original proposal

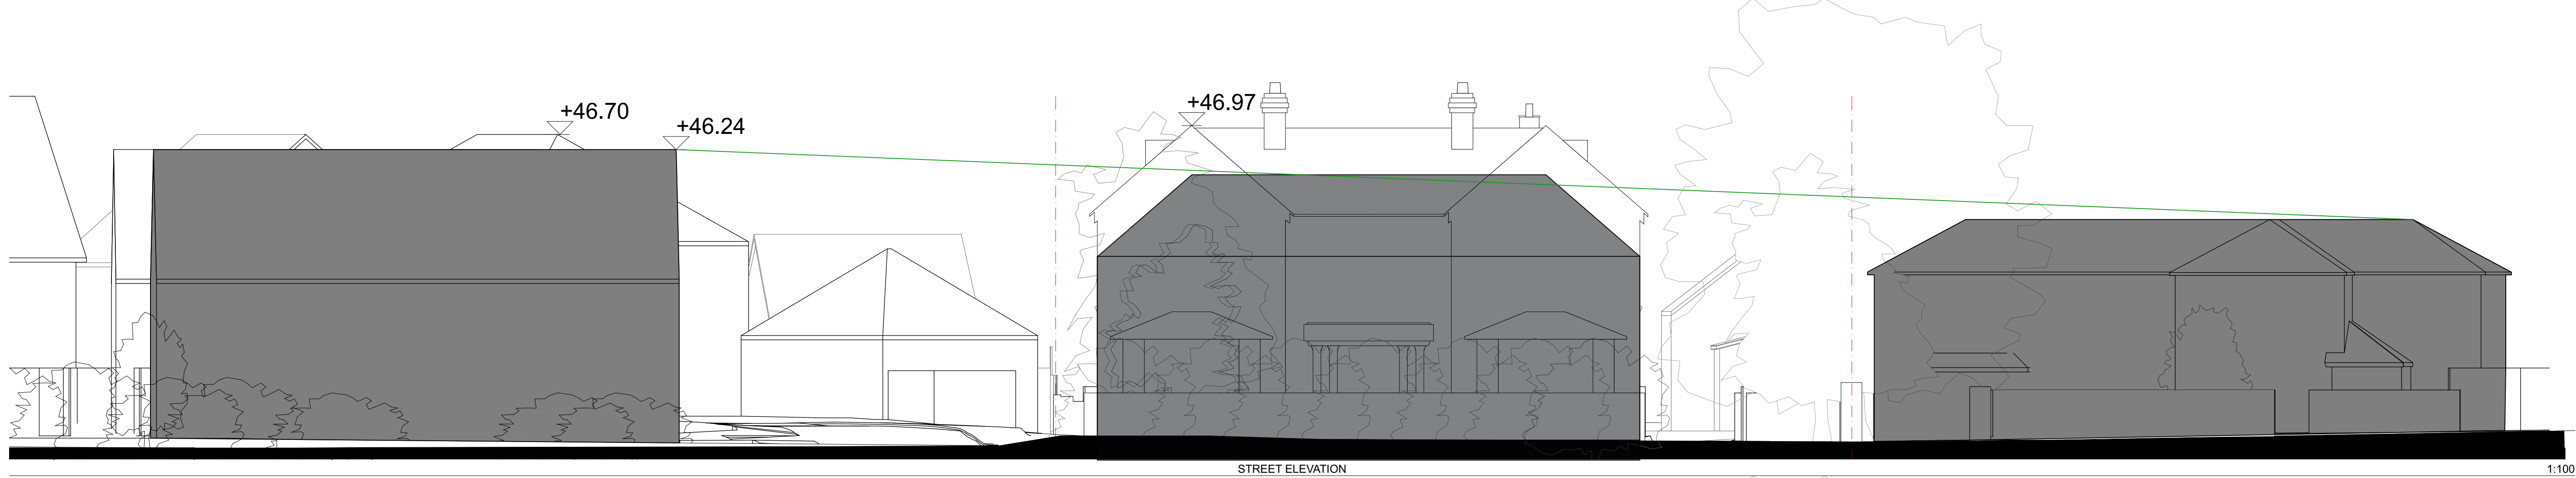
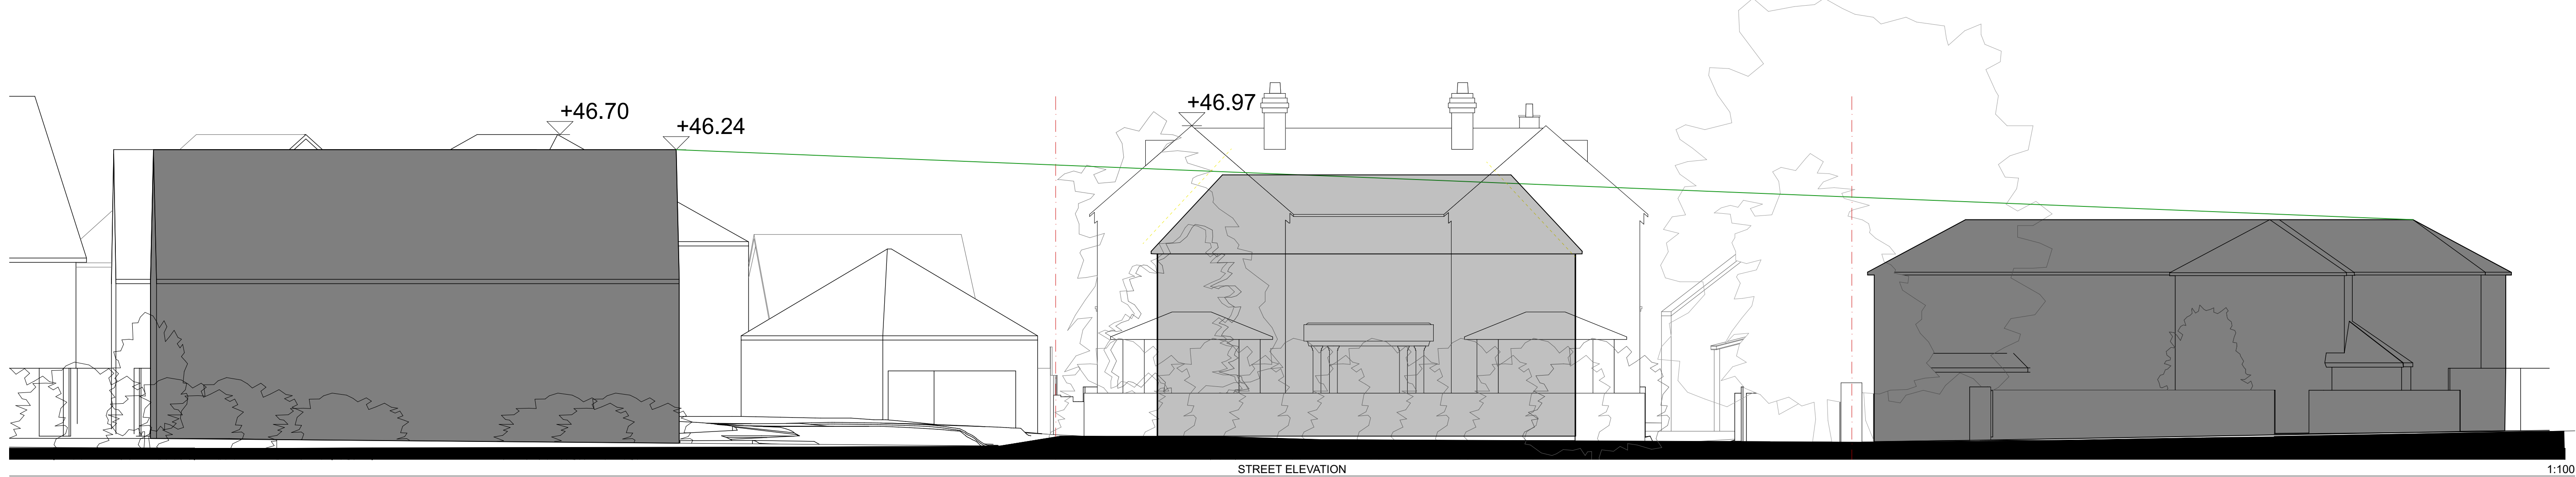
1m lower ridge

1.5m lower ridge

Simplified roof shape with hipped roof

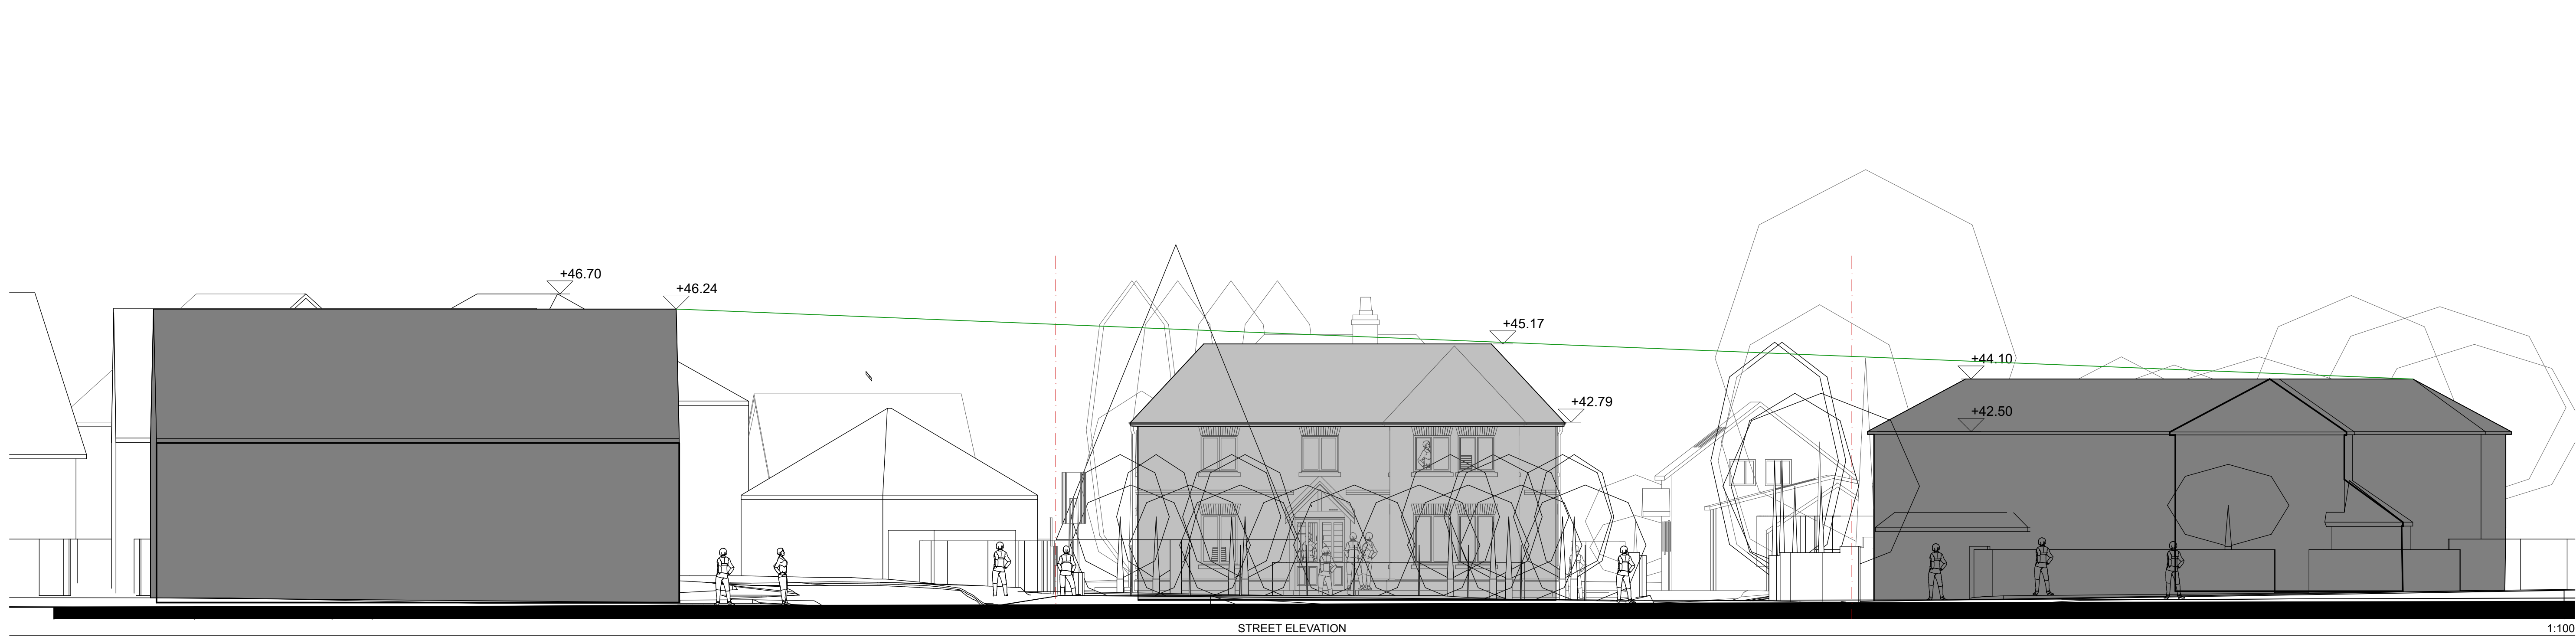
reduce width by 3m
reduce width by further 0.8m

Height and pitch adjusted
Building moved 0.8m east
Simplified roof shape with hipped roofs/ valleys
Added definition of elevation with hipped projection
Set back 45m from road
47' roof pitch to match existing cottage
Trees and Hedges shown
